# 2.0 Tottenham Street

Highlighted in the following pages is LB of Camden initial feedback response from internal consultees on Arthur Stanley House.

## 2.2 Tottenham Street Elevation Facade 6th floor level Office / Residential

Amended application - revised elevational treatment after discussions with LB of Camden March / April 2015.

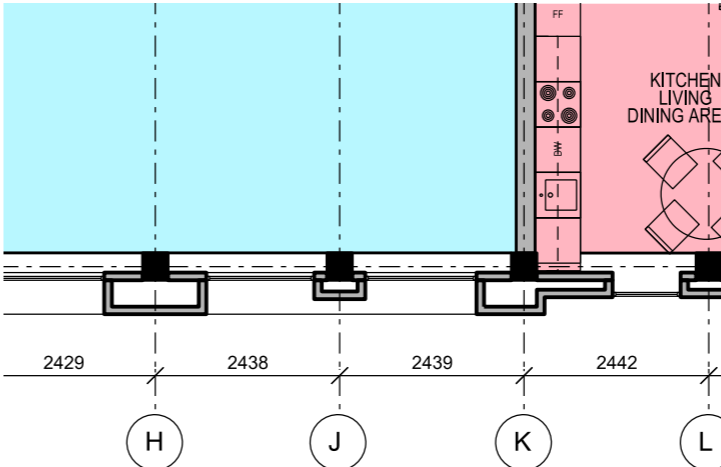
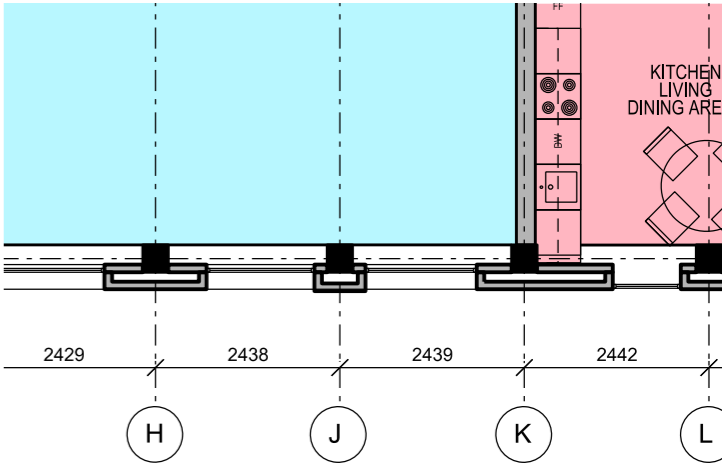
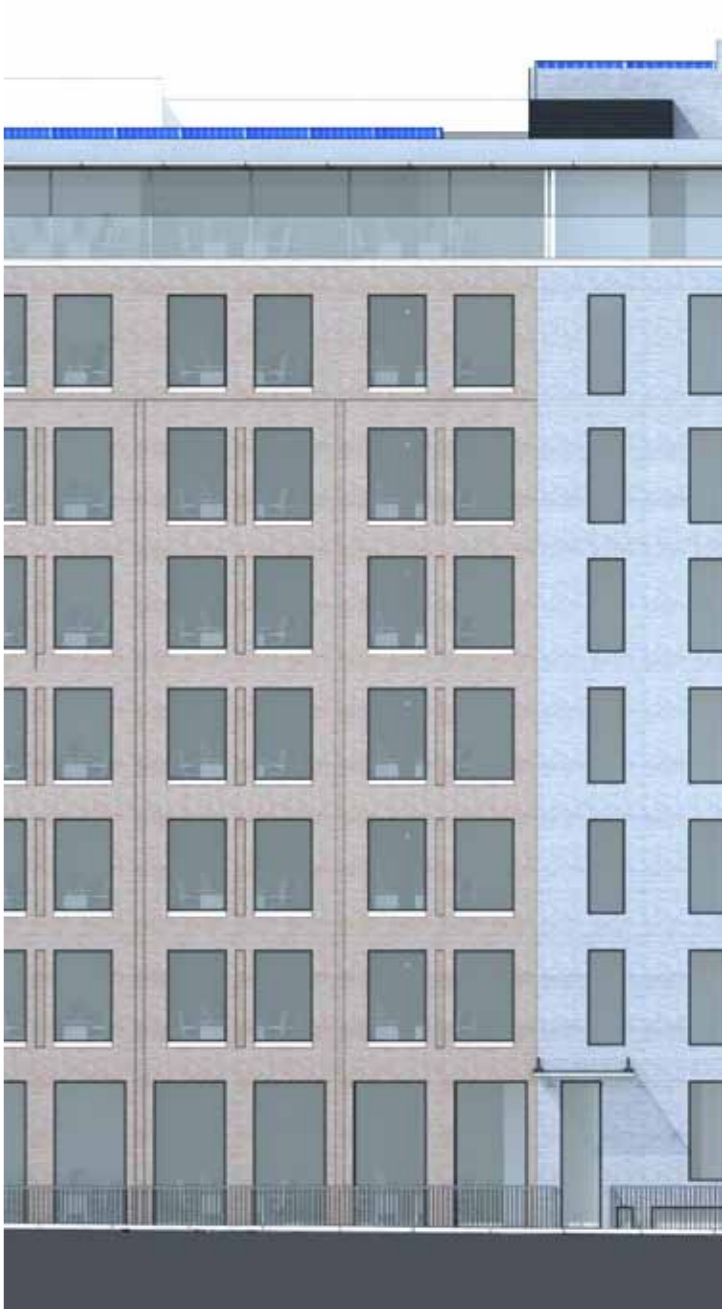
2.1 *It was agreed at pre-application stage that it may be possible to have a small amount of localised project to help modulate the facade beyond the building line, but not a wholesale moving forward of the façade. What is currently proposed shows a deep projection with limited detailing which looks bulky and clumsy in addition to the concerns of just moving the building forward into the site.*

*The projection needs to be reduced.*

The following pages illustrates how the facade depth has been reduced and further brick detailing has been incorporated into the building facade.

Further issues to address: setback of brick piers, articulation of brick piers within 200mm brick and insulation depth.

Figure 2.2.1 Tottenham Street facade - existing

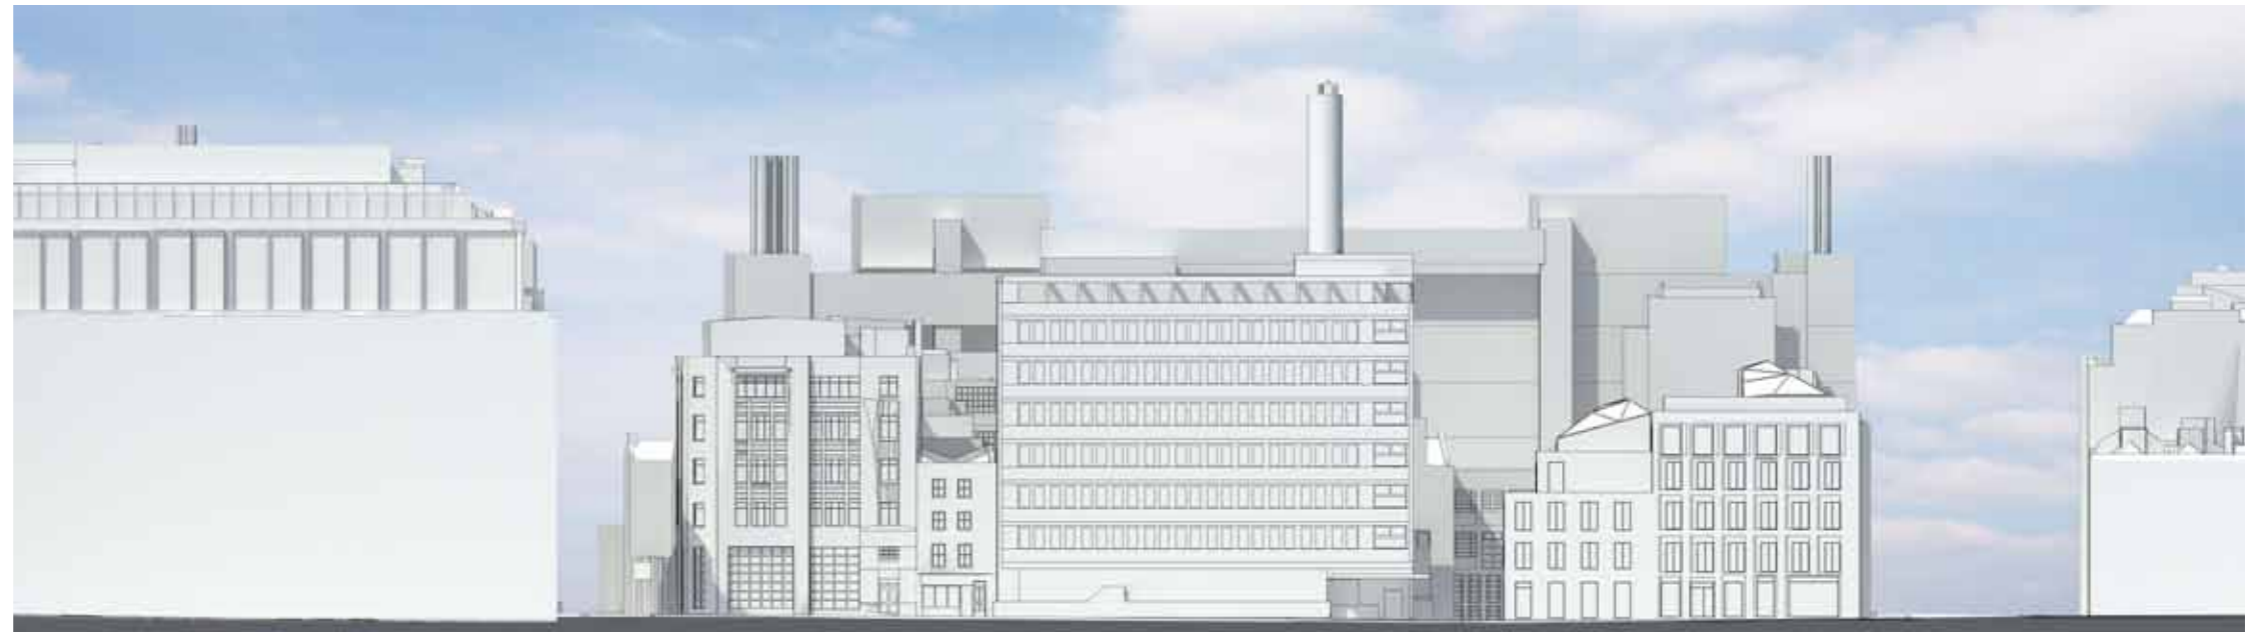
2.2.1 *There is also concern over the materials specifically the grey brick banding up the right hand side of the elevation which extends the width of the elevation at 6th floor level.*

*This design is not characteristic of the conservation area. If you wish to have a different facade treatment of the residential elements that would be acceptable and appropriate, however, it should not oversail the rest of the elevation.*

Figure 2.2.1 illustrates the existing Arthur Stanley House facade and street elevation.

Figure 2.2.2 shows how the facade overall height and massing has been reduced. The existing high level columns on level 07 will be removed and the existing chimney. Level 6 facade incorporated glazing to reduce the bulk of the building and treats the building at higher level with glazing. This option looks to reduce the facade coping level by 2 levels compared to the existing coping level. The new coping level will then match the adjacent level of the adjoining neighboring building on Tottenham Street.

Figure 2.2.3 shows the current planning application submission. Glazing was removed from level 6 and brick piers introduced. These brick piers matched the adjoining residential brickwork as this level projected out at the same depth compared to the lower floor projections.

Option 3 - preferred approach - incorporating further amendments after March 2015 application meeting.

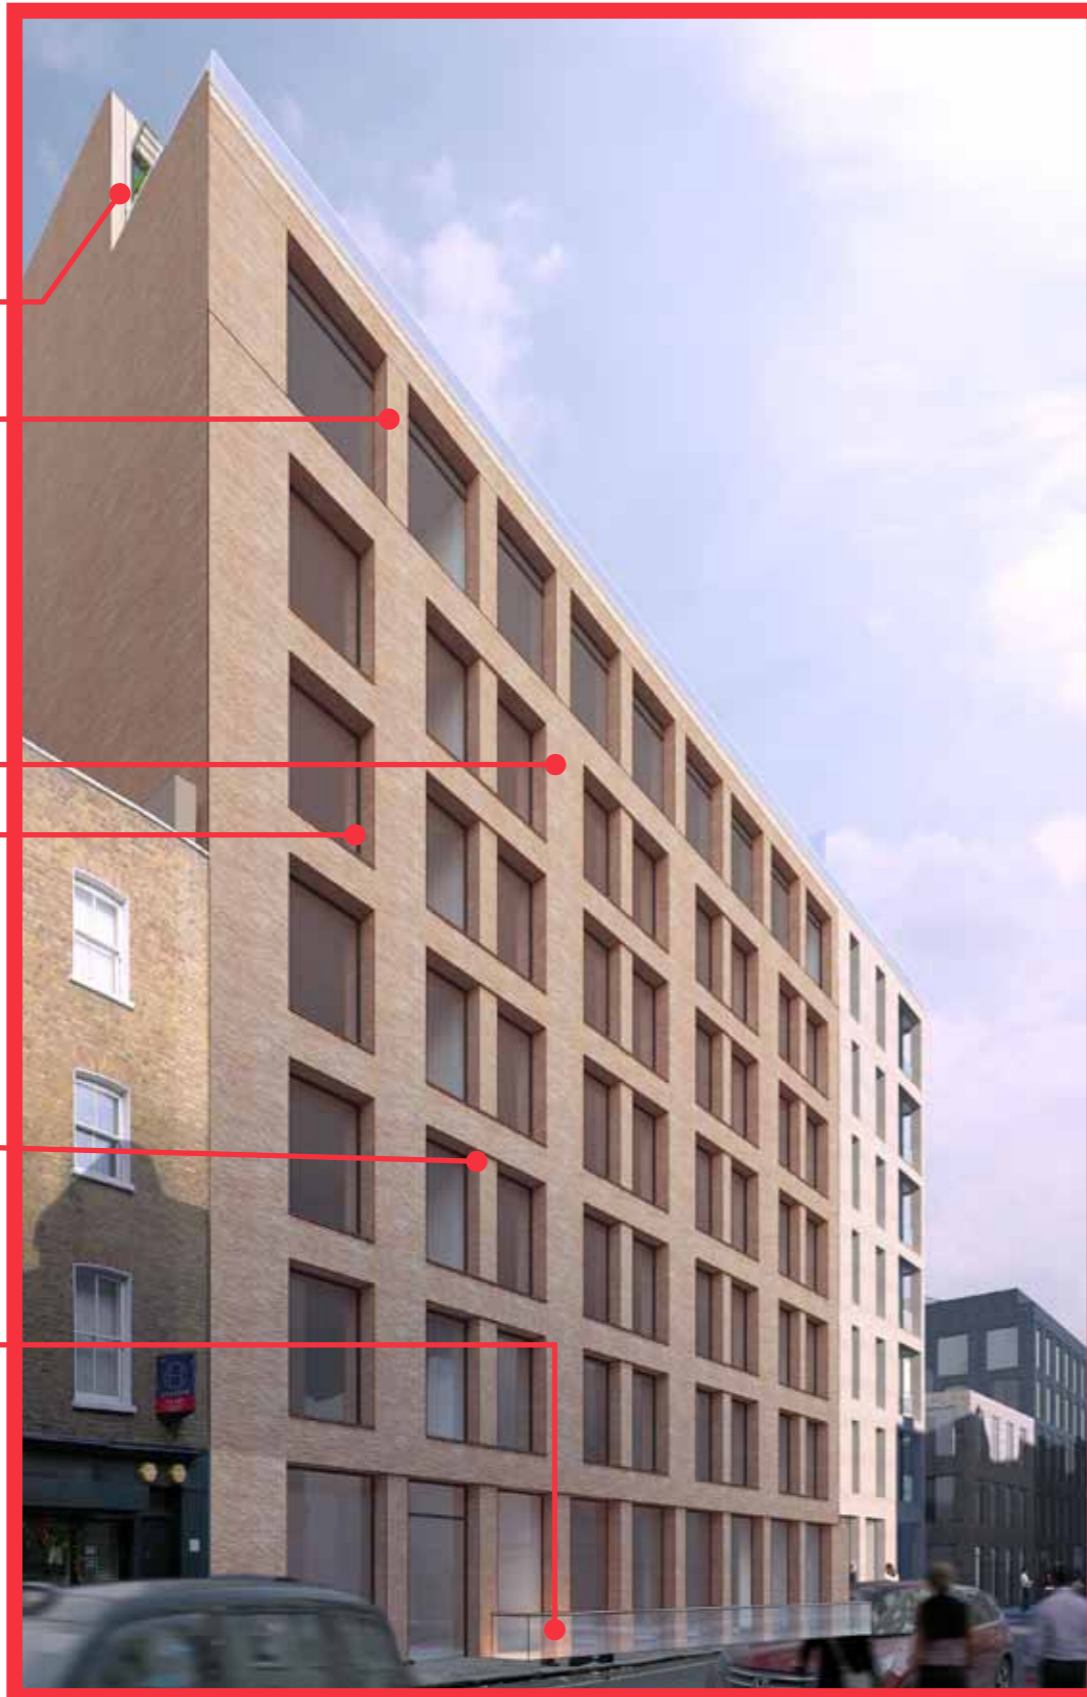
Further issues to address: setback of brick piers, articulation of brick piers within 200mm brick and insulation depth.

Panels removed between windows

Reduced brick piers and brick recess created.

Brick piers depth reduced

Brick piers depth reduced and brick articulation added

Glass balustrade removed and replaced with black railings

Lower ground and ground floor apartment reconfigured and lightwell introduced to improve daylight / sunlight to lower floor bedrooms.

### 2.3 Tottenham Street Elevation Facade 7th floor balustrade

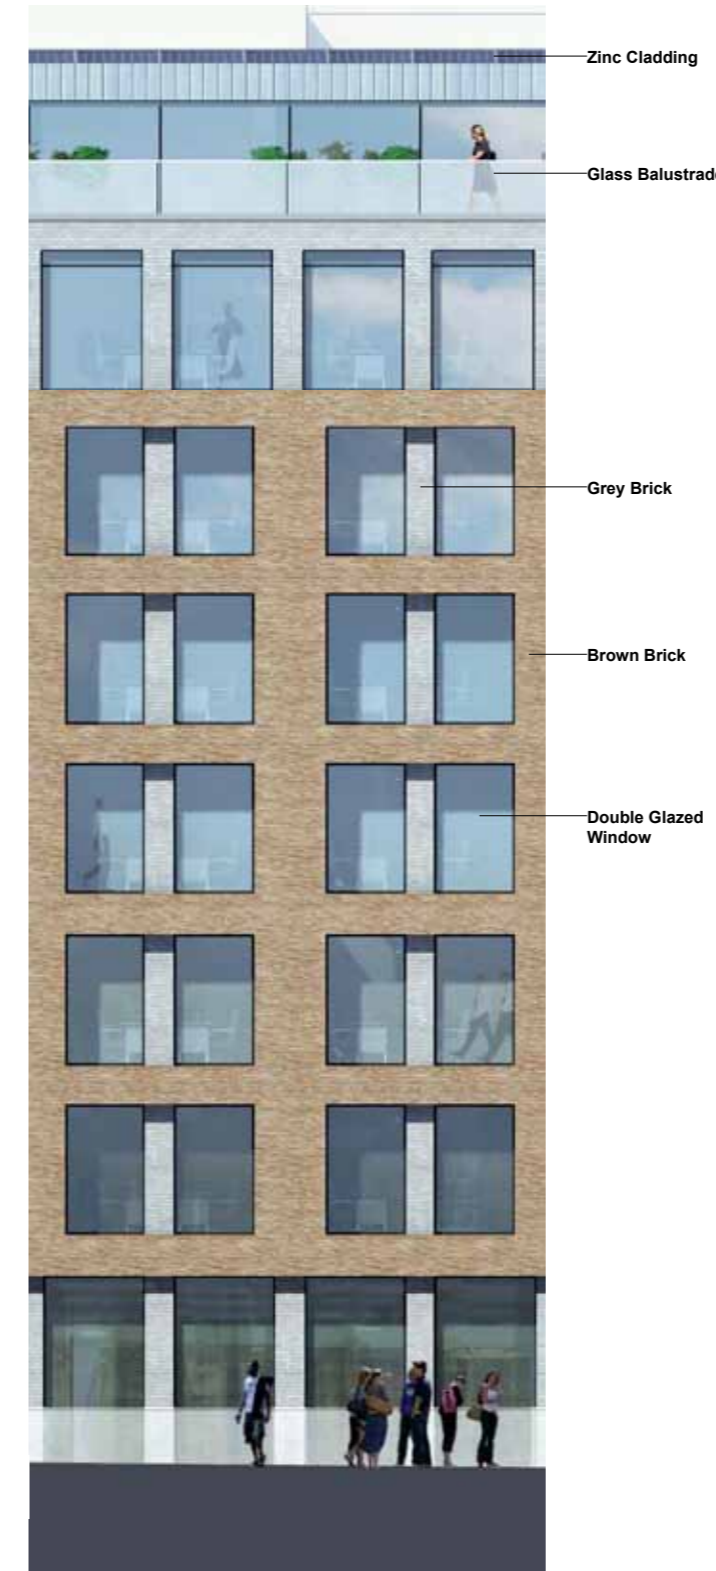
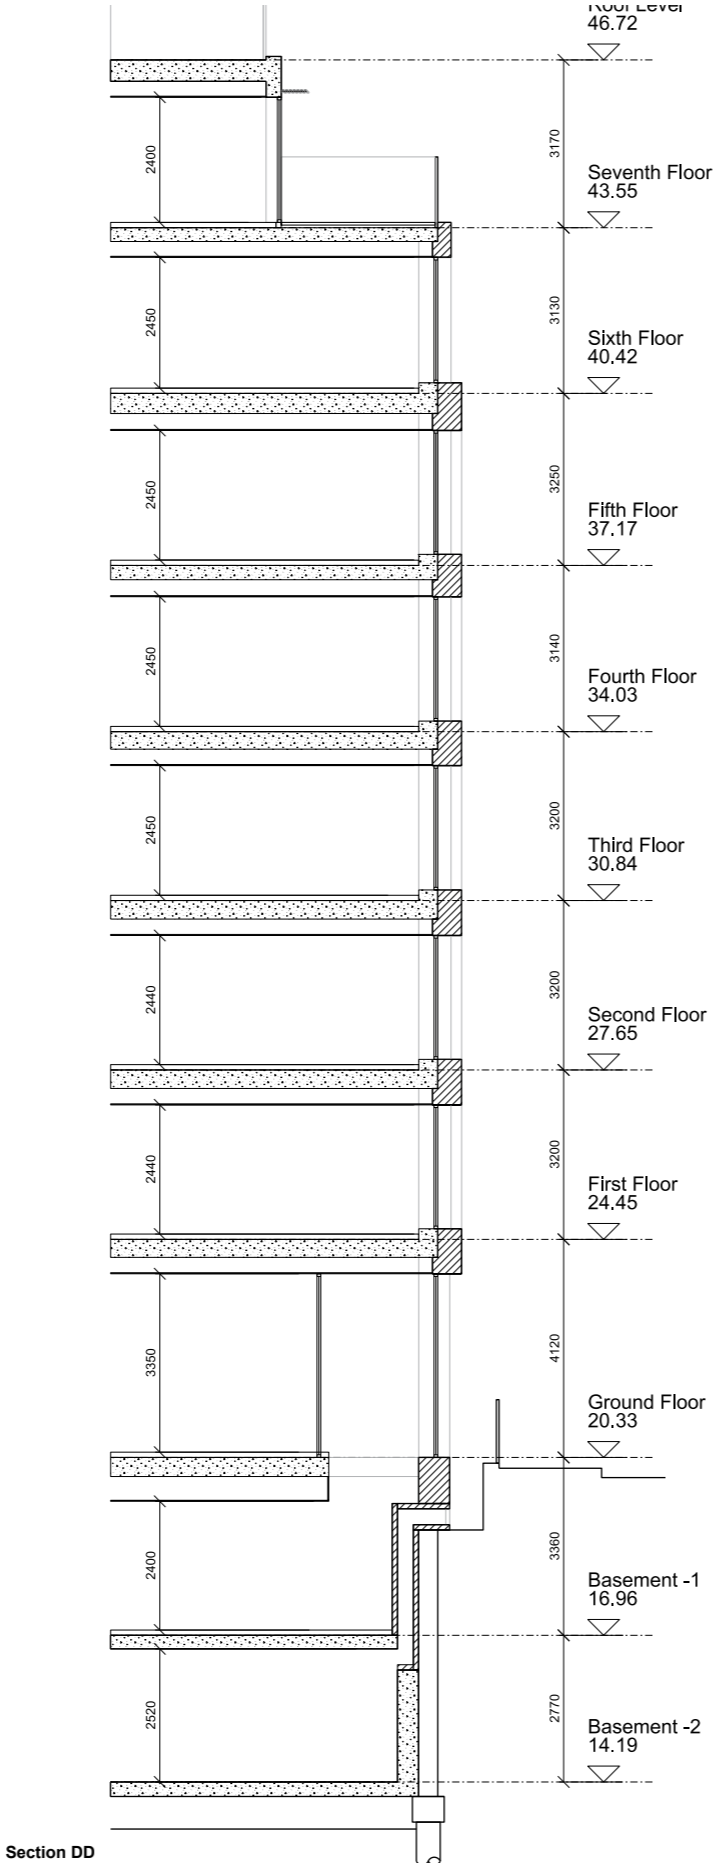
2.3.1 *No comments have been raised specifically relating to the sixth floor balustrade.*

*Balustrade type has been raised relating to Tottenham Mews and railings at ground floor level to Tottenham Street. See section 3.0 design response relating to Tottenham Mews.*

2.3.2 Design response. The glass balustrade at level 6 has been retained for the following reasons:

- Reduce the visual impact compared to black railings
- Create a visual barrier without any gaps reducing the risk of any items of falling onto people passing by below.
